**PLANNING COMMISISON SITE PLAN
COMPATIBILITY WAIVER REVIEW SHEET**

CASE NUMBER: SP-2015-300C **PC DATE:** June 14, 2016
June 28, 2016
PROJECT NAME: 2510 S. Congress **DISTRICT:** 3
ADDRESS OF APPLICATION: 2510 S. Congress
APPLICANT: Krug Development (David Krug) (773) 750-3706
AGENT: Wuest Group (Scott Wuest) (512) 394-1900
AREA: 66646.8 SF (Total Site Area)
WATERSHED: East Bouldin Creek (urban)
WATERSHED ORDINANCE: Comprehensive Watershed Ordinance (urban)
C.I.P. STATUS: N/A
T.I.A.: N/A
CAPITOL VIEW: N/A

CITY OF AUSTIN – DEVELOPMENT SERVICES DEPARTMENT
SITE PLAN APPLICATION – MASTER COMMENT REPORT

PROJECT NAME: **2510 S Congress**
LOCATION: **2510 S CONGRESS AVE**

SHEET
1 OF 31
SP-2015-0300C

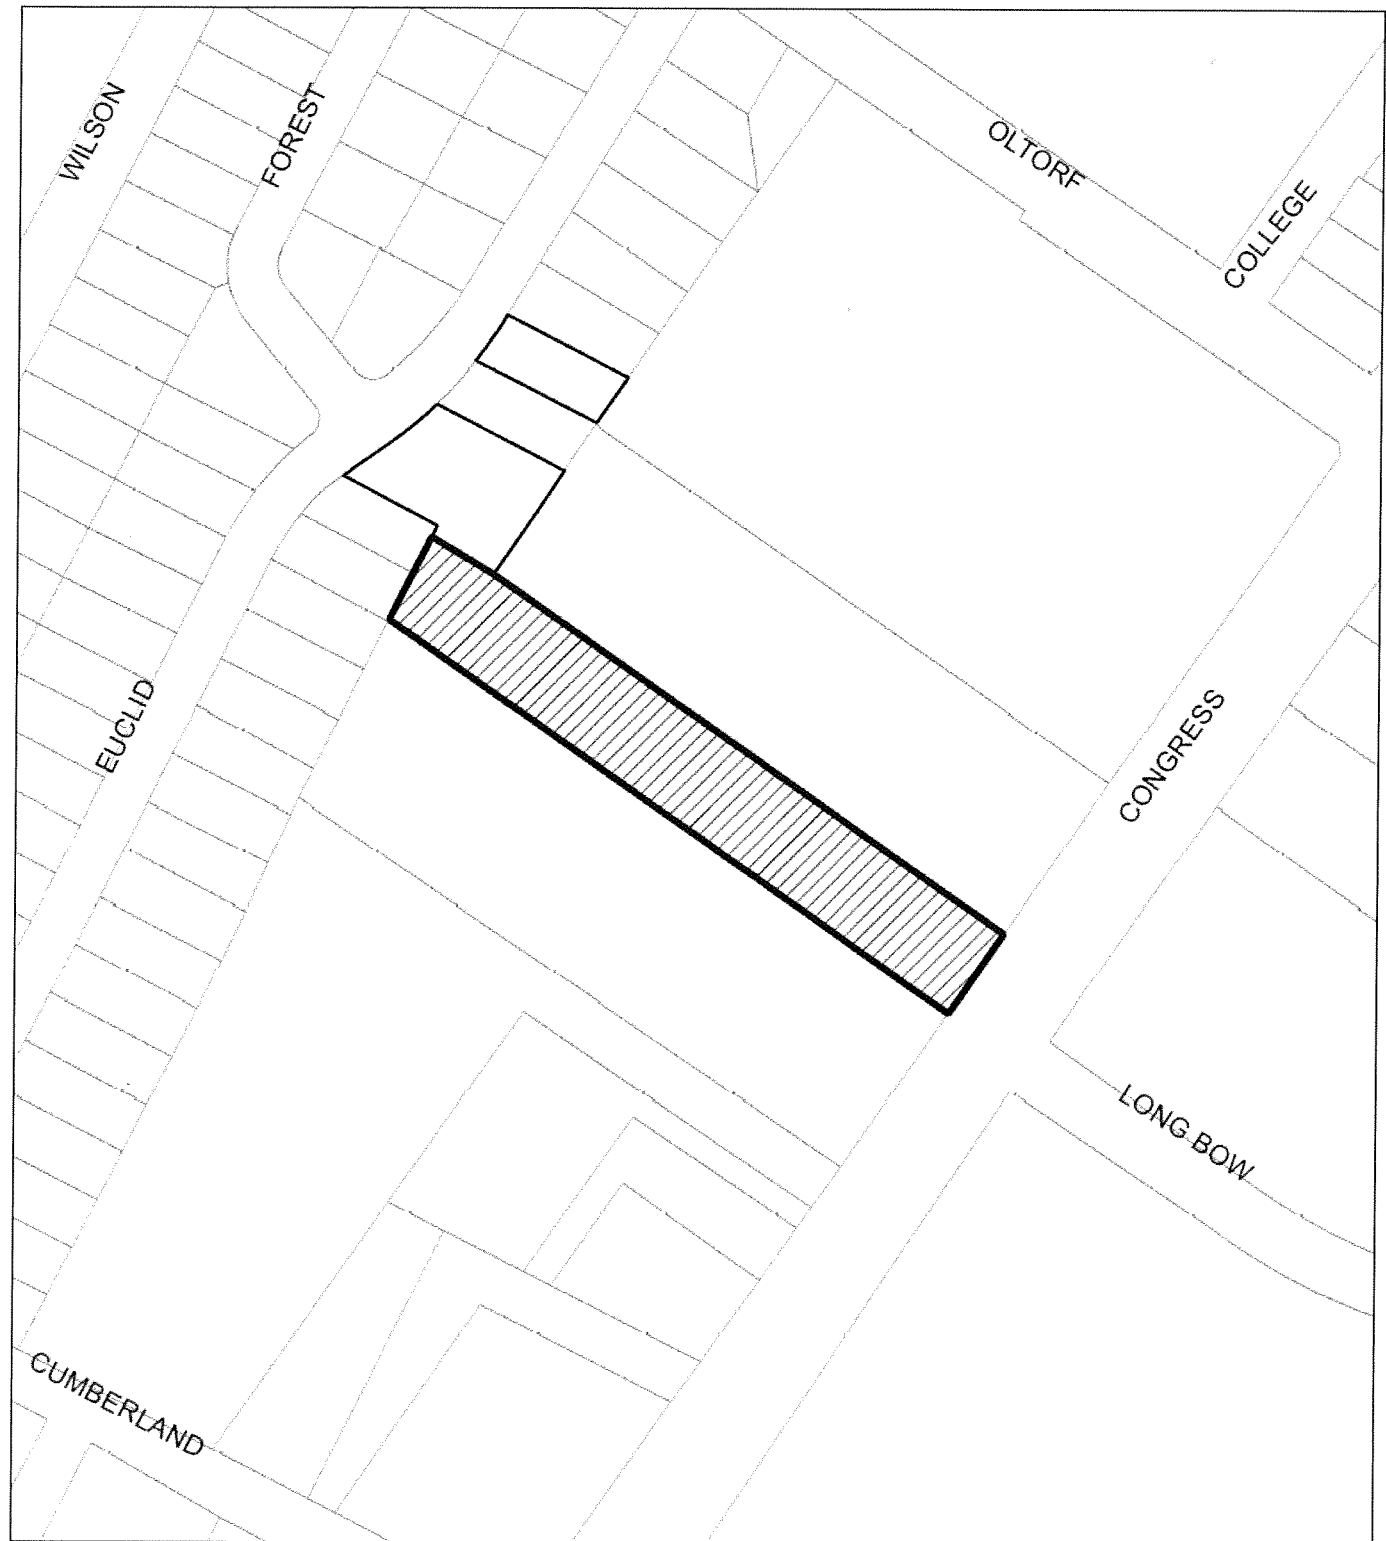
SP18. All structures, parking areas and driveways shall maintain a setback of 15 feet from the southern property line adjacent to an SF-5 or more restrictive use or district. [Section 25-2-1067]. The driveway is within this setback and must be either redesigned or receive a waiver from the Planning Commission.

SP20. An intensive recreational use, including a swimming pool, tennis court, ball court, or playground, may not be constructed 50 feet or less from adjoining property used or zoned as SF-5 or more restrictive. [Sec. 25-2-1067(F)] The swimming pool needs to be relocated at least 50 feet from the common property lines triggering compatibility or waiver must be granted by the Planning Commission.

U1,2- The swimming pool requires a compatibility waiver from the Planning Commission to allow its location within 25 feet of the triggering property.

U1,2- Comment pending Planning Commission Waiver Approval.
